SERVICE INFORMATION BULLETIN

APPLICABILITY: 2018MY Crosstrek
 2017-18MY Impreza

SUBJECT: Door Opening Body Flange Weatherstrip- Design Change

NUMBER: 12-233-18R
DATE: 02/19/18
REVISED: 08/15/18

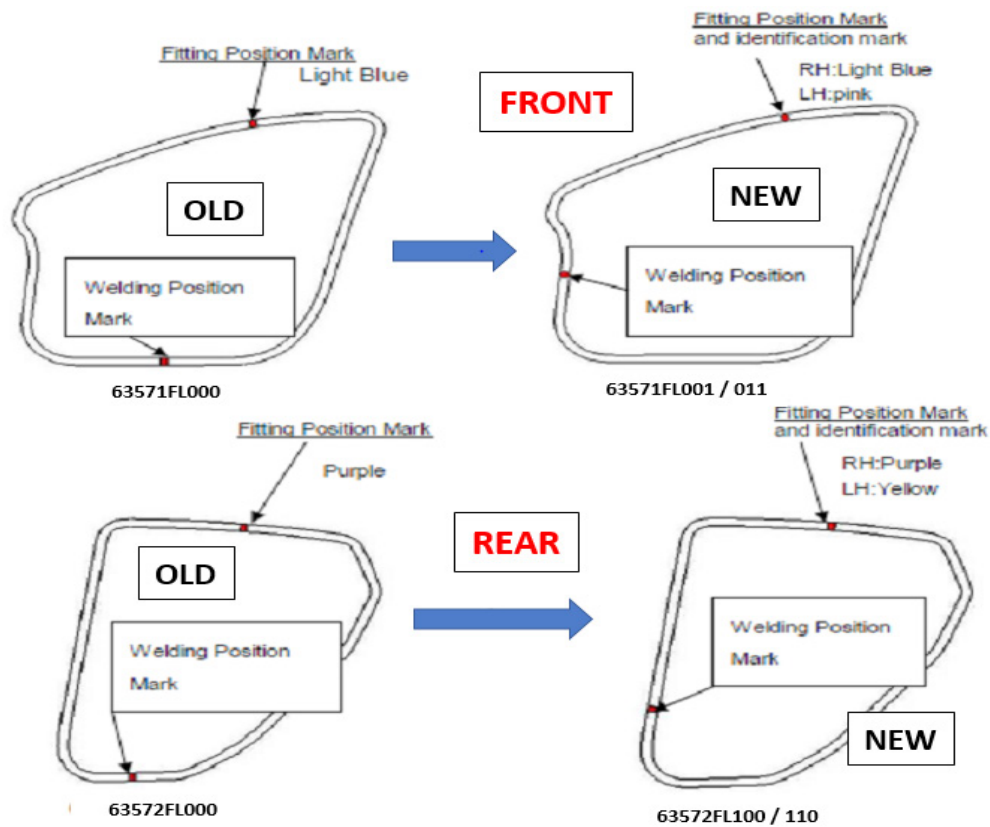
This bulletin announces a design change to the front and rear door body flange weatherstrips in response to concerns regarding the doors being somewhat difficult to close fully. The new parts make closing the doors easier while maintaining a tight seal against air and water intrusion and reducing outside road noise levels in the cabin.

The new door body flange weatherstrips were incorporated into production starting with VIN **J*237349**.

The previous versions of these weatherstrips were the same part number for the left and right. The new parts are made individually for each door opening flange (R/F, L/F R/R and L/R). The differences between the old and new parts are provided in the illustrations below.

Description	Part Number	Applicability
WEATHER STRIP BODY SIDE FLANGE	63571FL001	R/Front
	63571FL011	L/Front
	63572FL100	R/Rear
	63572FL110	L/Rear

IMPORTANT: Always confirm the Fitting Position Marks are installed in their proper positions as shown in the illustrations above.
